1385 HILLSIDE CIRCLE, (LOT 3) BURLINGAME, CA  
A.P.N.: 000-000-000

NEW RESIDENCE  
1385 HILLSIDE CIRCLE LOT 3  
BURLINGAME, C.A.  
A.P.N.: 000-000-000

REVISIONS	BY
PLANNING 10/06/25	PU

SITE DEMOLITION PLAN  
SCALE: 3/32"=1'-0"

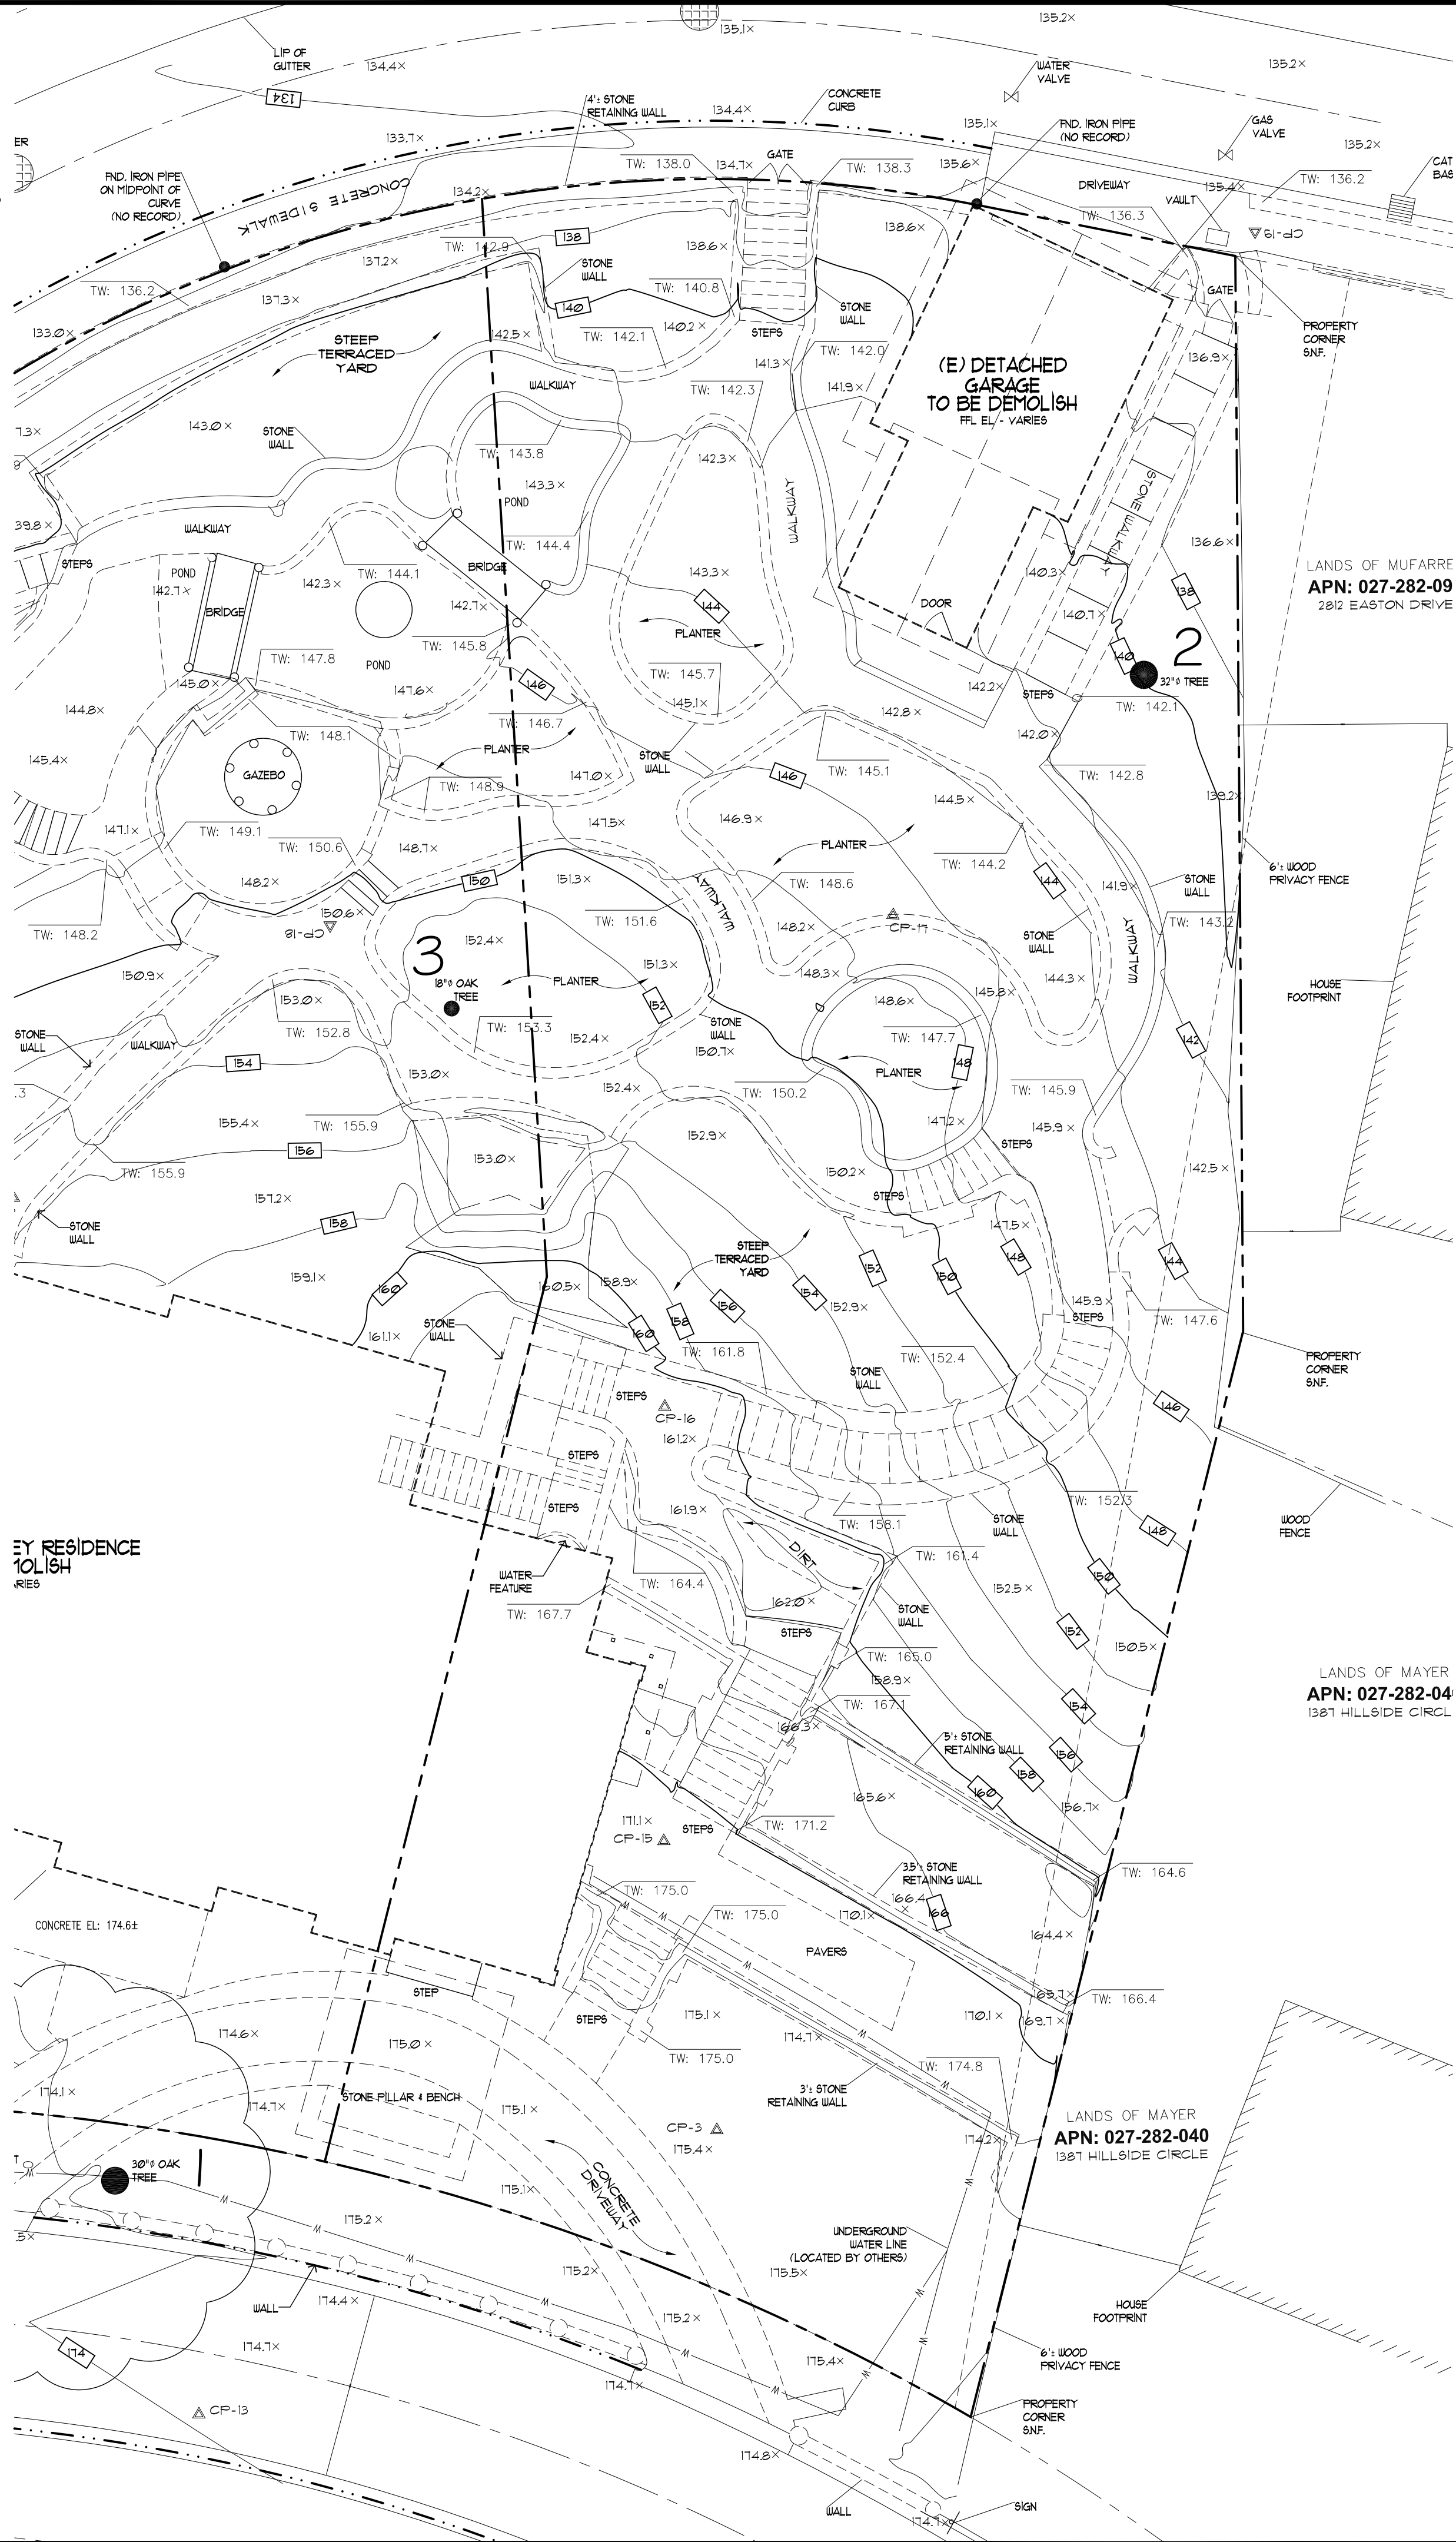
ENSURE THAT TREE PROTECTION SPECIFICATIONS ARE SHOWN GRAPHICALLY ON SITE PLANS FOR CONTRACTOR TO FOLLOW, AS FOLLOWS:

LOCATION OF ALL TREE PROTECTION MEASURES INCLUDING BUT NOT LIMITED TO FENCING, TRUNK WRAP, ROOT BUFFER, ARE TO BE GRAPHICALLY SHOWN ON DEMO PLAN A2 SO THAT CONTRACTOR CAN EASILY INSTALL AND EXECUTE THE TREE PROTECTION MEASURES.

LOCATIONS OF HAND DIGGING AND LOCATIONS OF WORK TO BE UNDER PROJECT ARBORIST SUPERVISION ARE TO BE GRAPHICALLY SHOWN ON THE RELEVANT SITE PLAN SO THAT CONTRACTOR(S) CAN EASILY UNDERSTAND AND EXECUTE THE SPECIFICATIONS. WORK WITH THE PROJECT ARBORIST TO PRODUCE ACCURATE INFORMATION ON THE RELEVANT SITE PLAN. SOME OF THE INFORMATION WILL BE ON THE A SHEETS AND SOME ON THE L SHEETS.

ARBORIST REPORT RECOMMENDS:  
RETAINING SOME OF THE DRIVEWAY NEAR TREE 1 AND BREAKING IT DOWN BY HAND LATER IN THE PROJECT. PUT THIS ON DEMO PLAN A2 SO CONTRACTOR CAN FOLLOW IT.  
CHANGING THE PATHWAY NEAR TREE 10 TO AVOID ROOT LOSS/DAMAGE. WHERE IS TREE 10? HAS THE PATHWAY BEEN CHANGED?

ARBORIST REPORT IS BASED ON REVIEWING L PLANS DATED JAN 2024, LOT 1 A PLANS DATED 10-26-22, LOT 2 A PLANS DATED 10-26-21 AND LOT 3 A PLANS DATED 10-26-21. NO CIVIL PLANS REVIEWED. NOTE THAT THE CONTENT OF CIVIL PLANS MAY NECESSITATE A CHANGE IN THE ARBORIST RECOMMENDATIONS.

INDICATE THAT AT LEAST 3 SINGLE-TRUNKED LANDSCAPE TREES WILL BE PRESENT ON EACH LOT, AS NOTED BELOW.  
PER CHAPTER 11.06, THIS PROJECT REQUIRES 3 SINGLE-TRUNKED LANDSCAPE TREES FOR LOT 3.  
TREES MAY BE EXISTING OR NEW.  
REQUIRED TREES MAY NOT BE FRUIT OR NUT TREES, PALMS, ITALIAN CYPRESS OR JAPANESE MAPLE.  
REQUIRED TREES MUST HAVE A MATURE HEIGHT OF OVER 15 FEET.  
ALL REQUIRED TREES MUST BE IN GOOD CONDITION AT THE FINAL ARBORIST INSPECTION.  
STREET TREES DO NOT COUNT TOWARDS THE REQUIRED TOTAL.

PROVIDE THE BOTANICAL NAME (GENUS AND SPECIES) AND LOCATION OF THE REQUIRED LANDSCAPE TREES, AND WHETHER THEY ARE EXISTING OR NEW, FOR EACH LOT.
